SERVICE BULLETIN # 00169

SUBJECT: Acceptance problem with tokens or larger coins

MODELS: All GIII Venders with EVS-2 software (PO # 1478 to 1504)

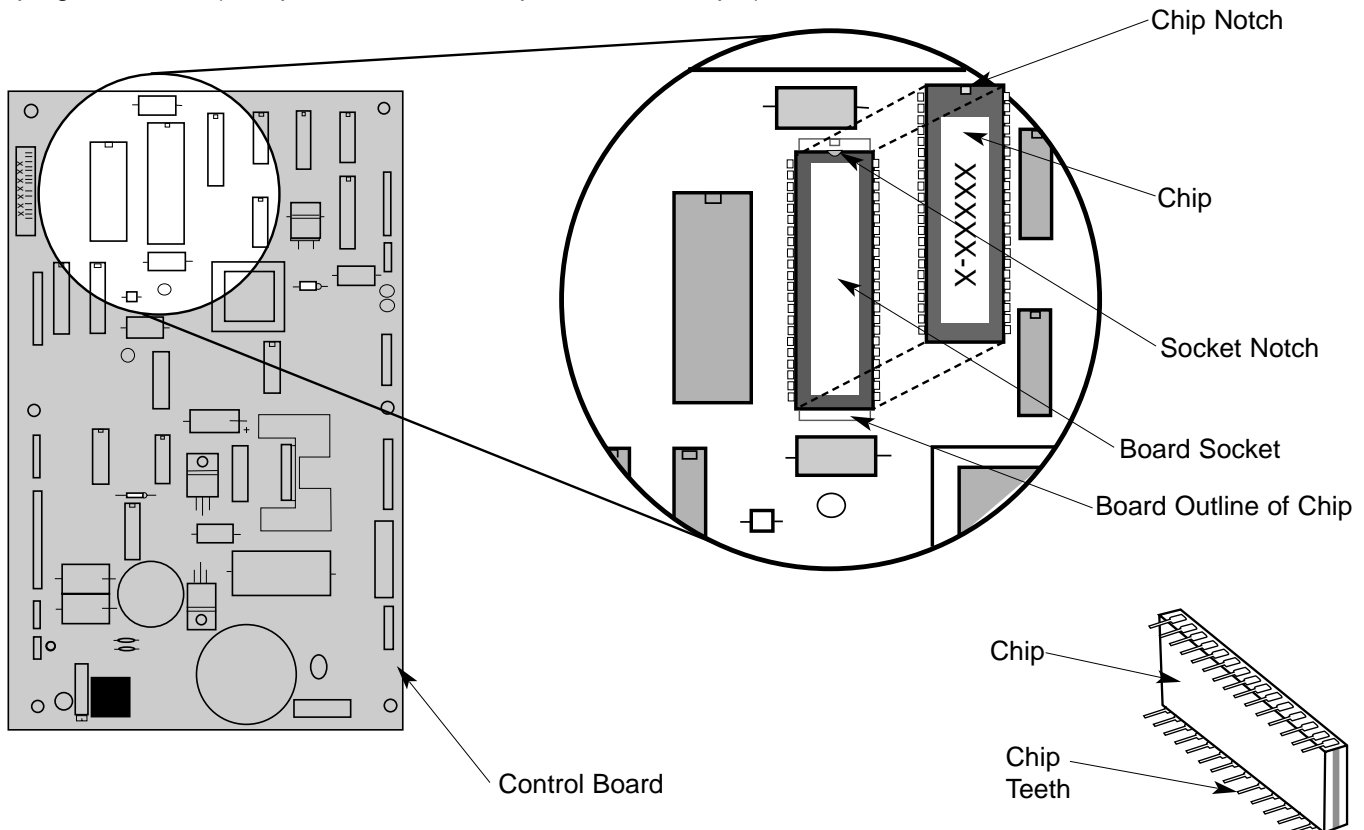
Reason for Fix:

This applies to GIII venders with E.V.S. software which are demonstrating erratic acceptance of tokens or larger coin types (8-15). Changers have the ability to accept 16 different coin types 0-15 (0 being the smallest denomination and 15 being the largest denomination). If you have EVS 67121-2 chip or EVS 67122-2 and are having an acceptance problem with tokens or larger coin types; the above chips will solve this problem for all G-III venders with EVS software.

1. Remove power from vender by unplugging vender's main power cord from the AC voltage power source (wall outlet)
2. Using a chip extractor (or small screwdriver) remove 67121-X or 67122-X chip.
3. Position the new chip by aligning the chip notch with the socket notch of the control board.
4. Insert the right-side teeth of chip into the board socket, then push chip slightly to the right until the left-side teeth line up with the board socket, then push the chip into the board socket.
5. Make sure all chip teeth are inserted into the board socket.
6. Reprogram vender (i.e. space to sales, vend price, column depth).
